## KSZ8041 Silicon Errata and Data Sheet Clarification

This document describes known silicon errata for the KSZ8041 family of devices, which includes the following:

## Module 2: Pin Strapping failures due to 1.8V core power slow ramp-up

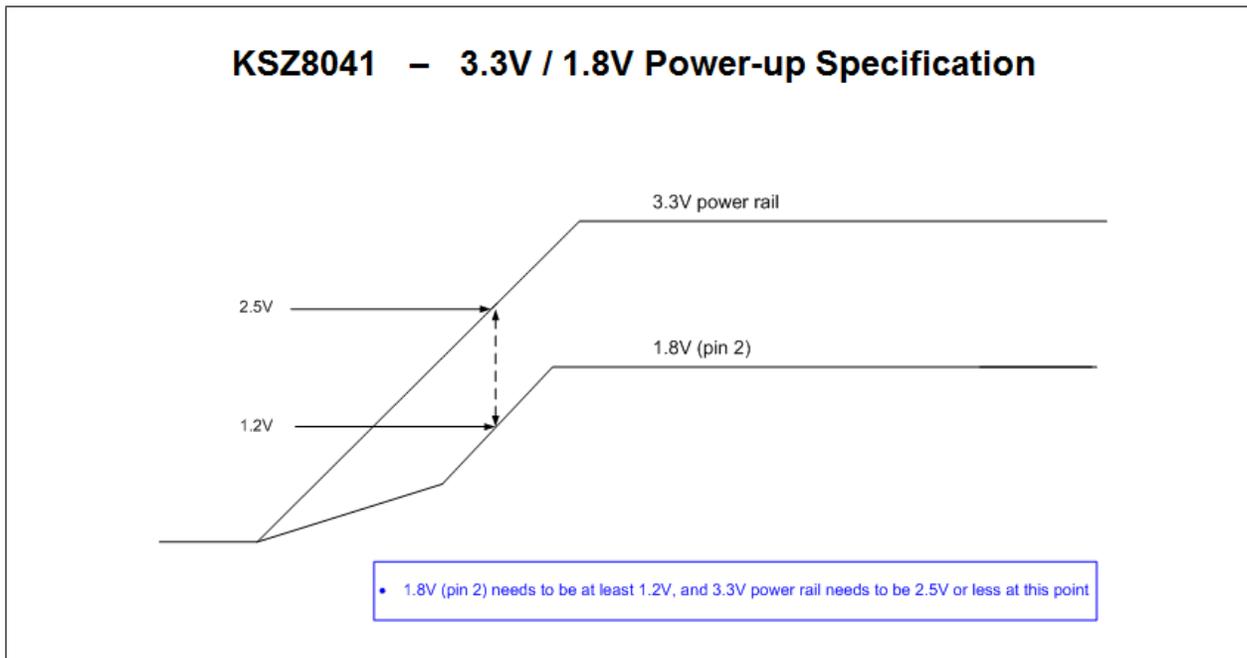
A small percentage (<1%) of devices can potentially encounter pin strapping failures with fast 3.3V supply rise times (<150us) or slow core rail rise times, due to a large bulk storage capacitor value (10uF or greater) for the 1.8V core.

When this errata occurs, pin strap values may not be correctly latched.

Reduce the 1.8V core bulk storage capacitor from 10uF to 1.0uF and ensure the 3.3V supply rise time is 250us or greater.
